Modification to Minister's Approval

Section 75W of the *Environmental Planning and Assessment Act 1979*

Application Number:	MP 06_0228
Proponent:	Shoalhaven Starches Pty Ltd
Approval authority:	Minister for Planning
Project:	Shoalhaven Starches Expansion Project
Date of original approval:	29 January 2009
Modification:	MP 06_0228 MOD 9 – Packing Plant

Modified Packing Plant

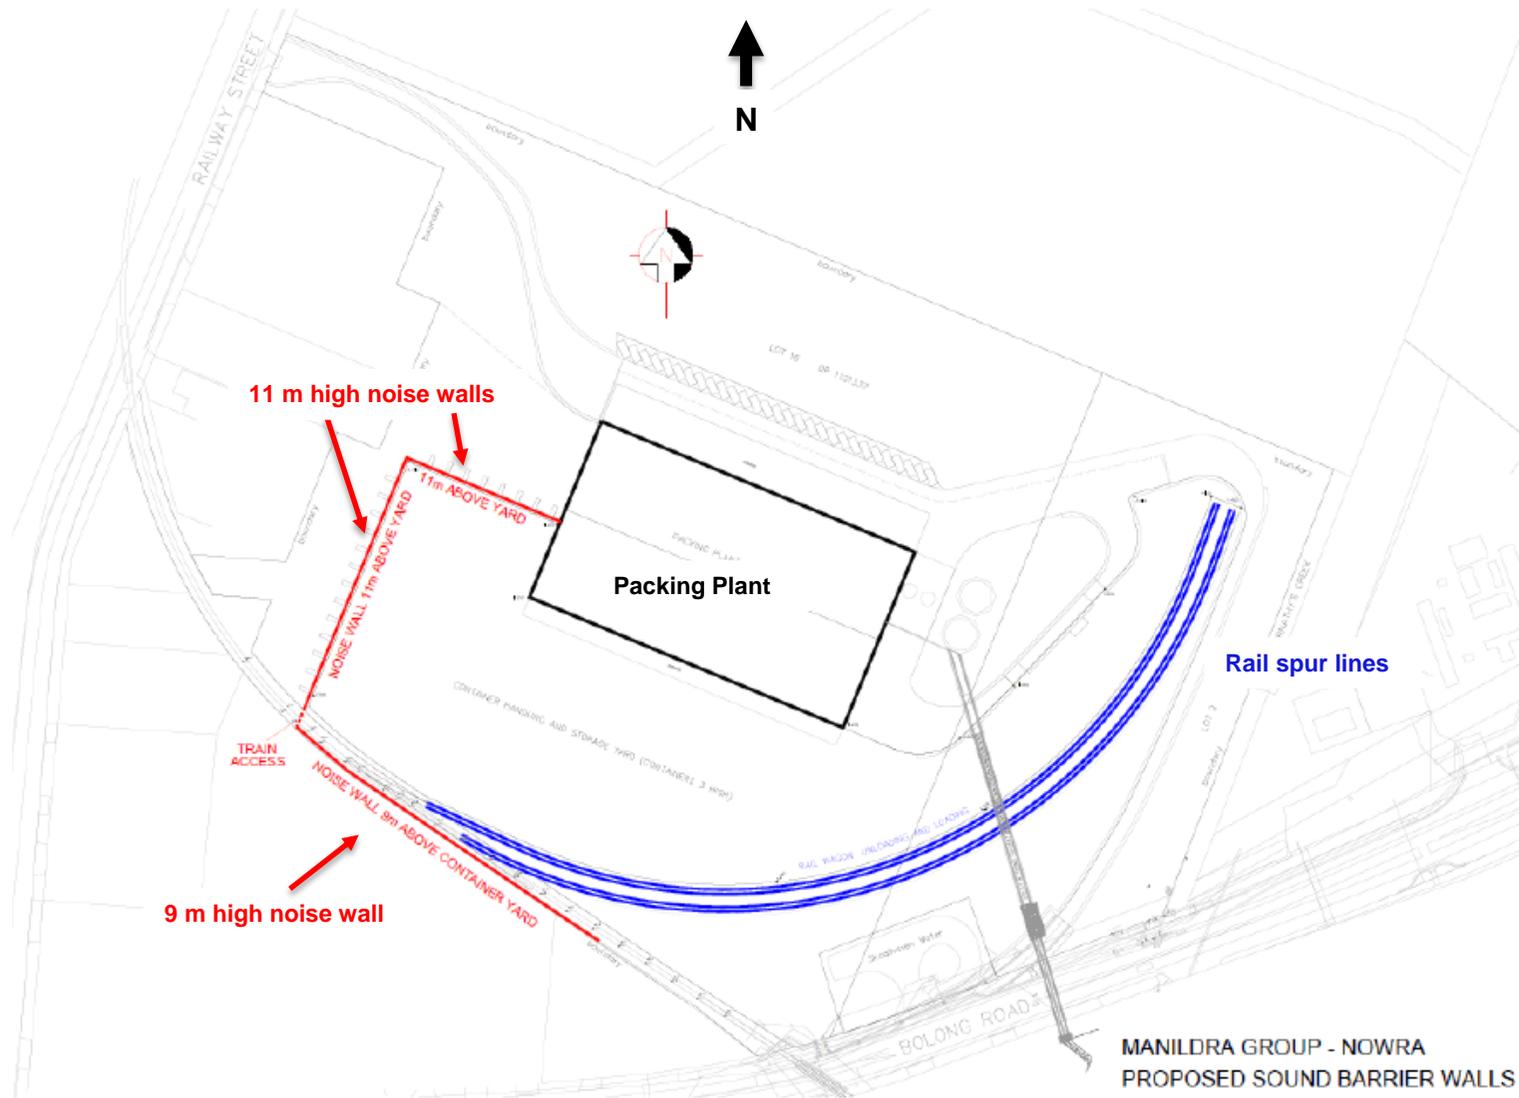
- j) modification proposal MP 06_0228 MOD 9, accompanying Environmental Assessment and plans dated March 2016, prepared by Cowman Stoddart Pty Ltd and Noise Assessment for Night Time Operations dated November 2016, prepared by Harwood Acoustics (see Appendix 2I).

14F. Prior to the commencement of operation of the packing plant, the Proponent shall provide evidence to the satisfaction of the Secretary to confirm that the design specifications detailed in the EA for MOD 9 have been implemented. The design specifications include:

Noise Barrier Walls

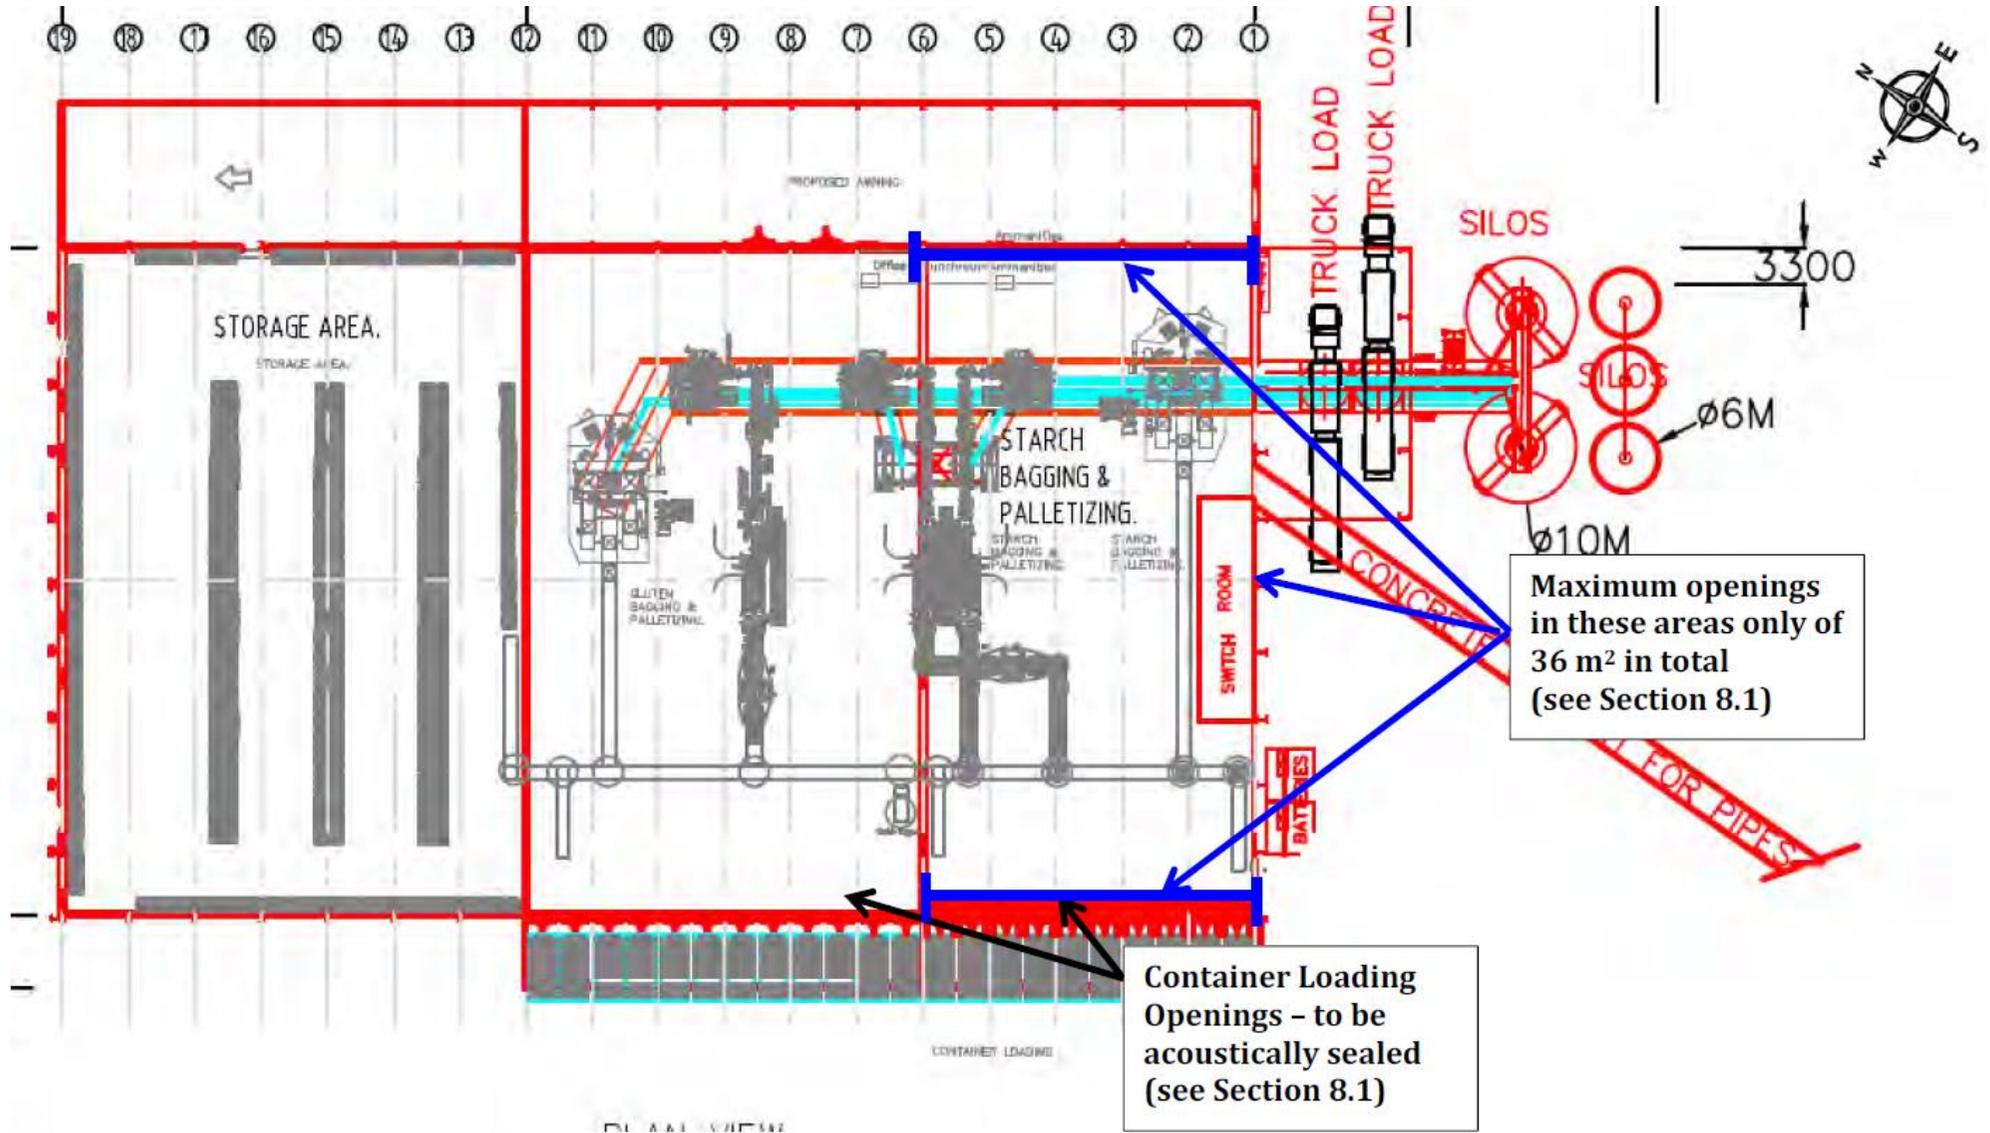
- e) permanent sound barriers a minimum 11 m high relative to the finished ground level of the container storage yard. Barriers shall extend along the entire length of the north-western boundary of the container storage area, connecting to the packing plant along the north-eastern boundary (see the figure in Appendix 2I);

- f) permanent sound barriers a minimum 9 m high relative to the finished ground level of the container storage yard, along the south-western side of the rail spur lines, as shown in the figure in Appendix 2I; and

- g) sound barriers shall be constructed as solid masonry walls, or other equivalent material, without holes or gaps, other than a maximum of 50 mm at the base.

Location of Building Openings

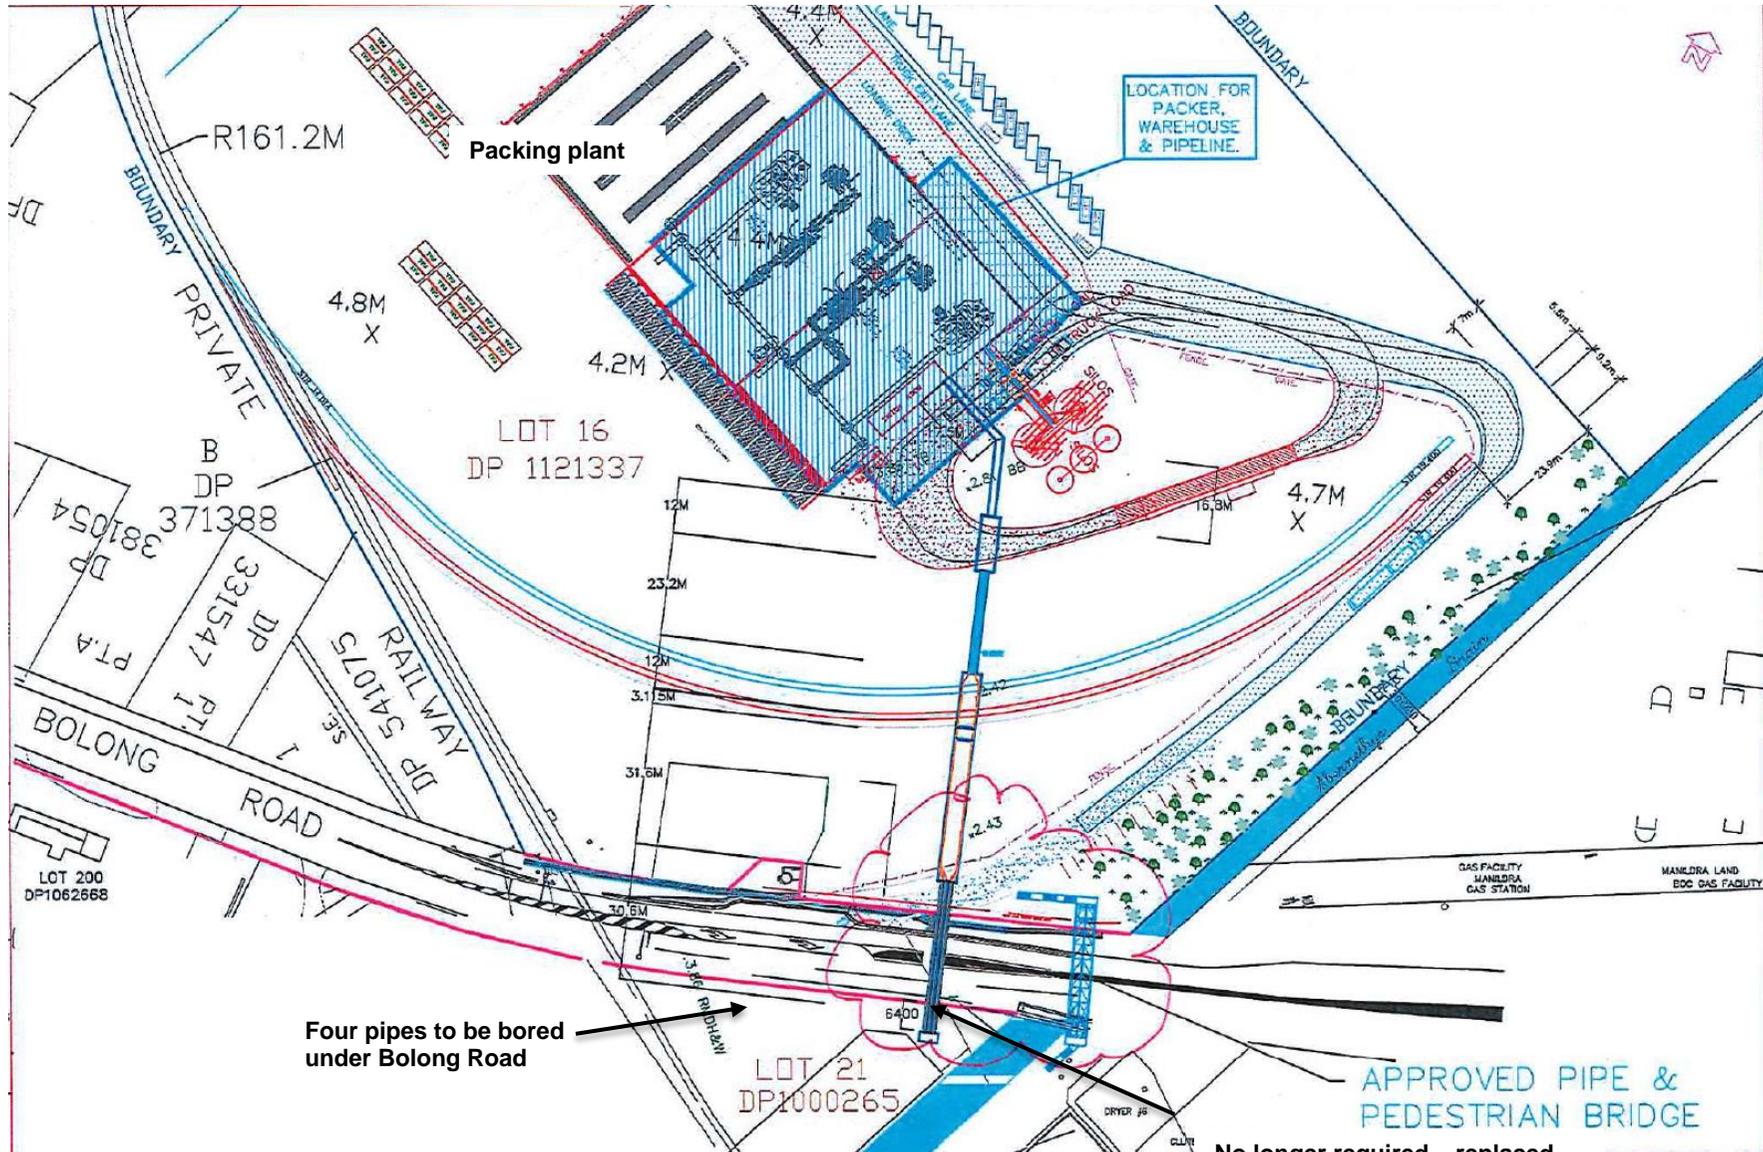
- b) all external doors are a minimum 44 mm thick, solid core timber construction, or equivalent material, in well-sealed frames;
- c) building openings without acoustic treatments shall not exceed 36 square metres and shall be located in the south-eastern part of the packing plant building, as shown in Appendix 2I;

Under-bore pipes under Bolong Road

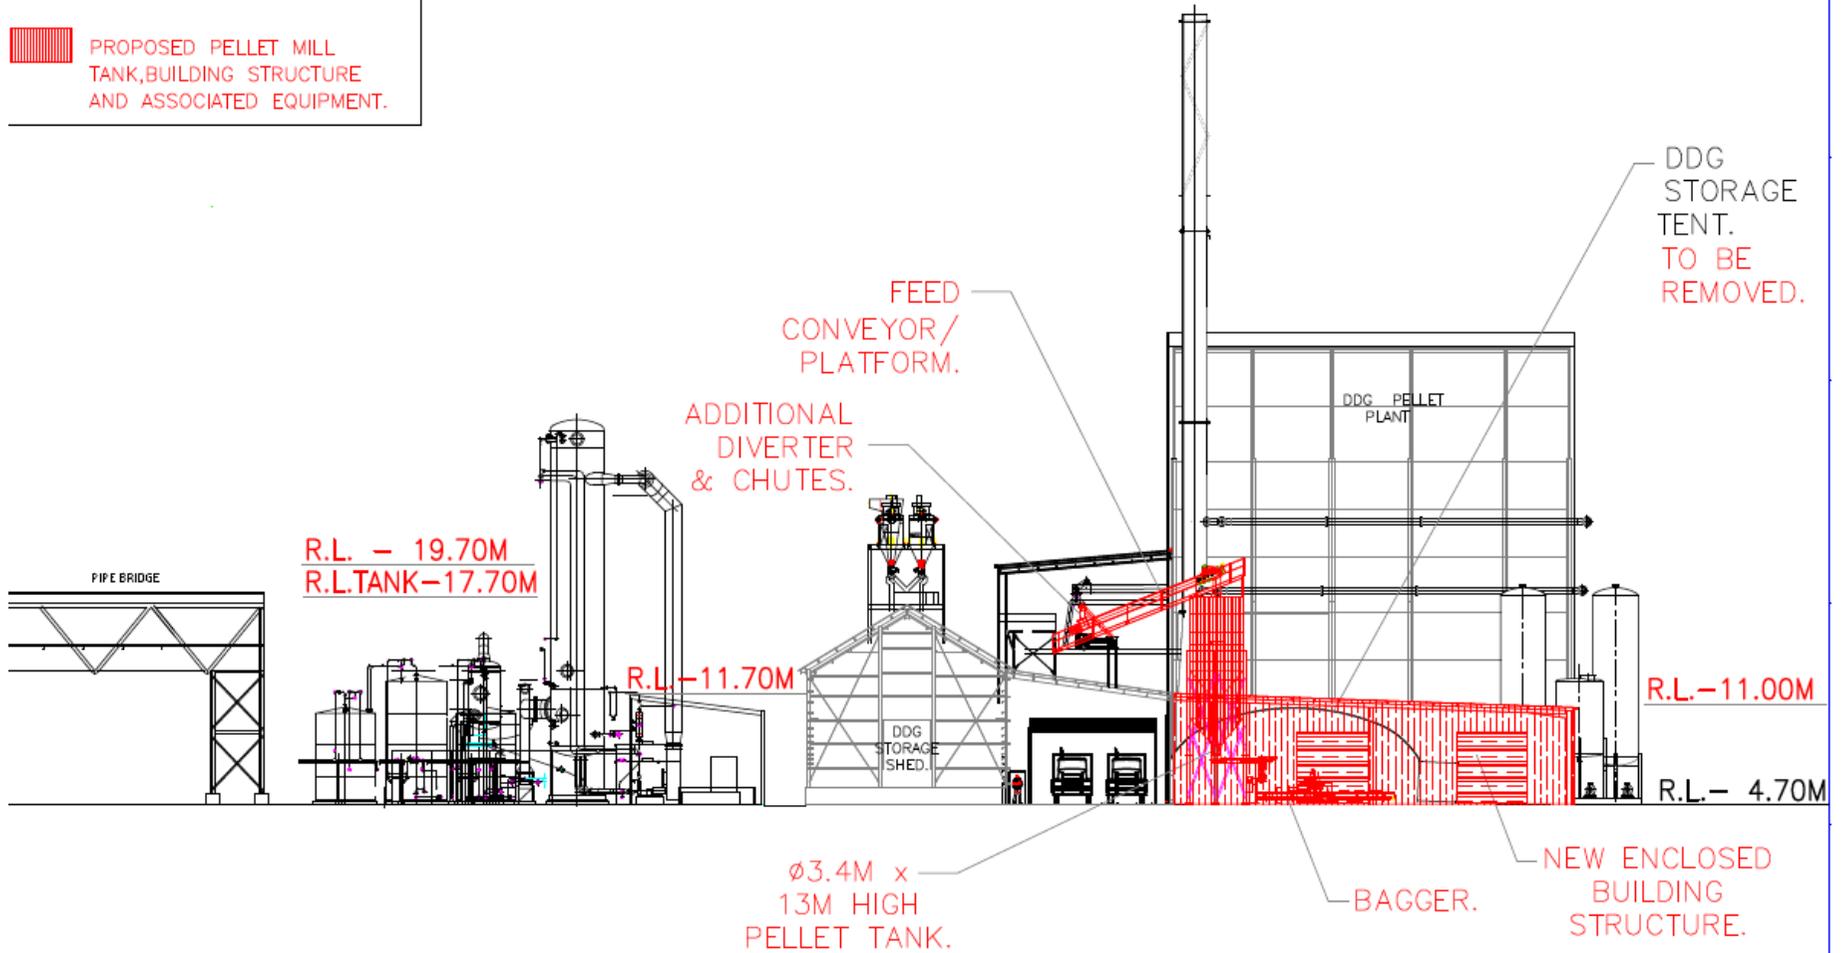
Four pipes to be bored under Bolong Road

APPROVED PIPE & PEDESTRIAN BRIDGE

No longer required - replaced by pipes under Bolong Road

- 10A. The Proponent shall:
 - a) consult Telstra and Jemena during preparation of detailed design for the under-boring of pipework under Bolong Road as described in MOD 9;
 - b) contact Telstra and Jemena at least two weeks prior to the commencement of the under-boring works;
 - c) ensure that mechanical excavation or boring works are undertaken in accordance with the requirements of Telstra and Jemena in order to protect the private infrastructure assets; and
 - d) complete restoration works to the ground surface and footpath.
